Re: Application to Inject
Buffalo 34 Federal #1
Township 18 South, Range 33 East, NMPM
Section 34: 1980 FSL 660 FWL
Lea County, New Mexico

C-108 Application for Authorization to Inject
SWD 34-18-33
L-34-18S-33E
Lea County, NM

From: Jones, William V., EMNRD
Sent: Wednesday, April 11, 2007 6:01 PM
To: Brian Collins (engineering@marbob.com)
Cc: Ezeanyim, Richard, EMNRD; Kautz, Paul, EMNRD
Subject: SWD Application: SWD 34-18-33 #1 API No. 30-025-30909 (was the Buffalo 34 Fed #1)

Buffalo Federal Unit #4

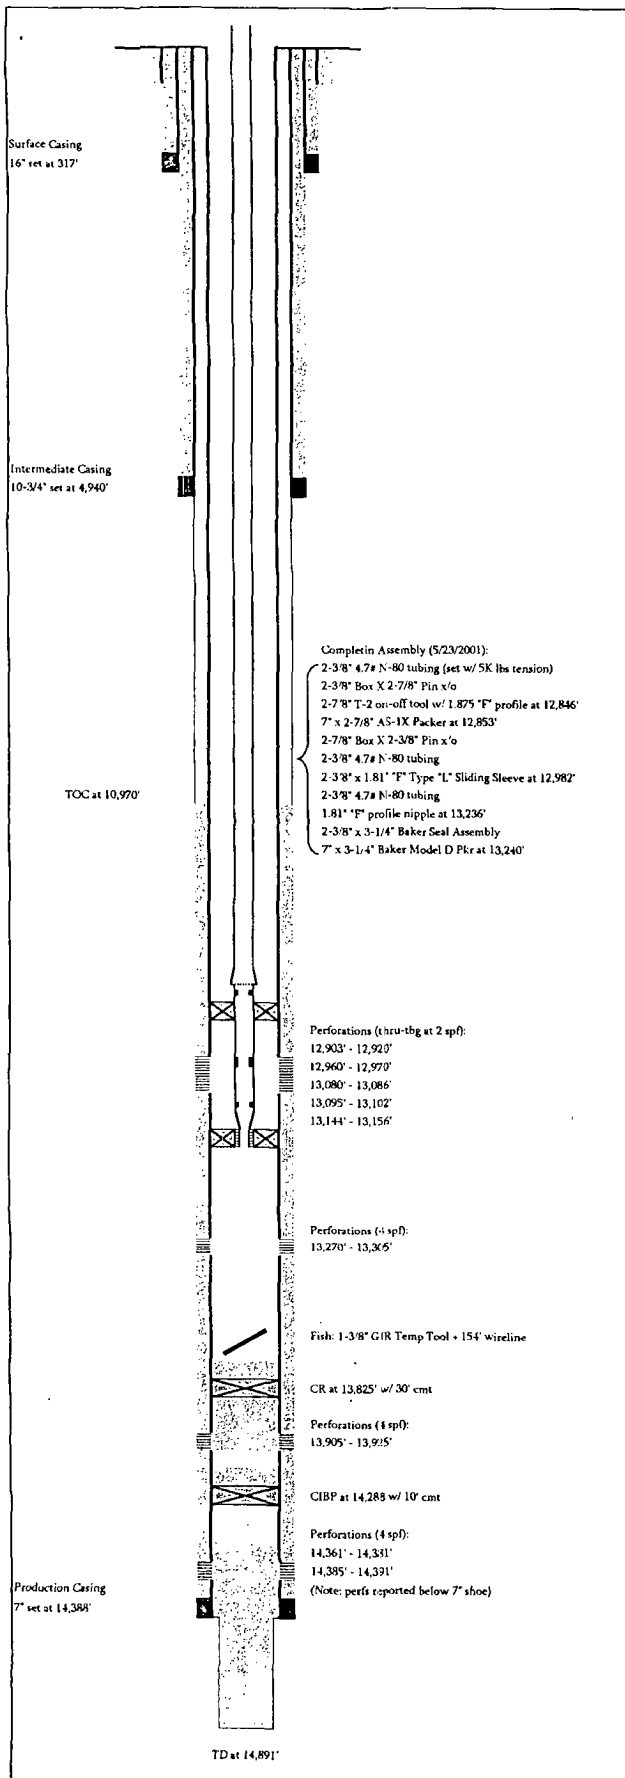
Bold Energy objects to the request of Marbob to convert the referenced well into a saltwater disposal well. Bold Energy, LP is operator of the offset well, Buffalo Federal Unit #4, which is currently producing. We have attached, a well diagram showing that Bold does not have cement covering the proposed disposal depth and as a result believe that injection into this interval may compromise the integrity of this wellbore.

SWD 34-18-33

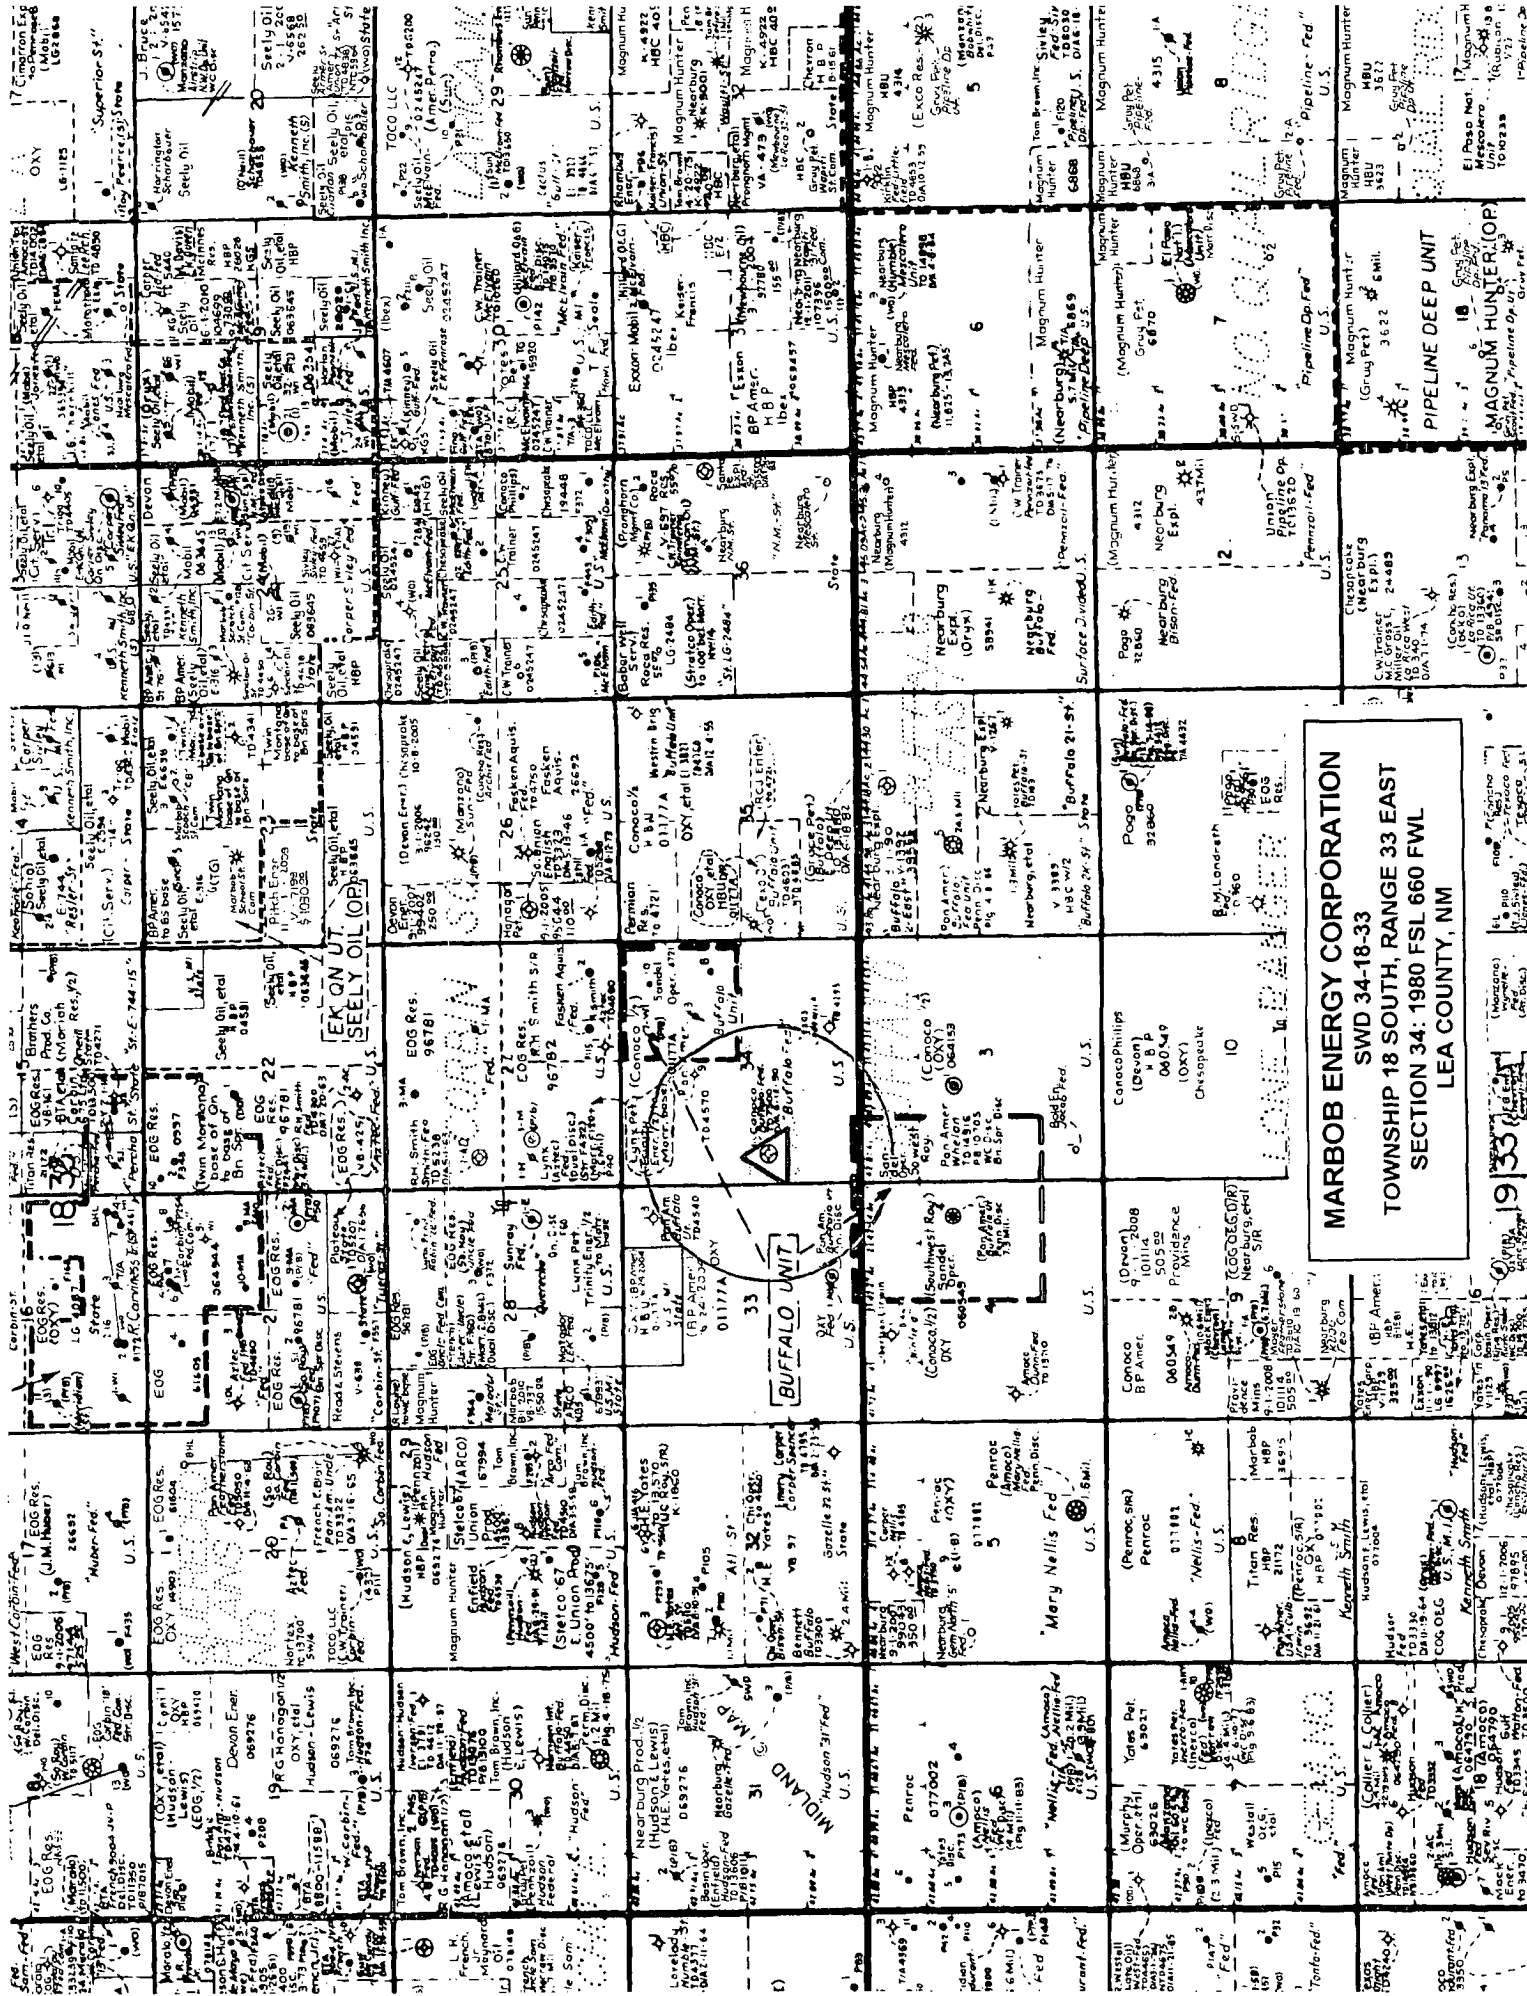
- 1) Send a copy of the notice as actually posted in the Newspaper.
- 2) Please have your geologist send tops of the members of the Delaware. The tops on the imaged log were different than tops on the application and this is north of the Reef area.
- 3) To cement casing from 7500 feet to 1270 feet over the San Andres and the Salt intervals may be unpredictable without the use of a DV tool?
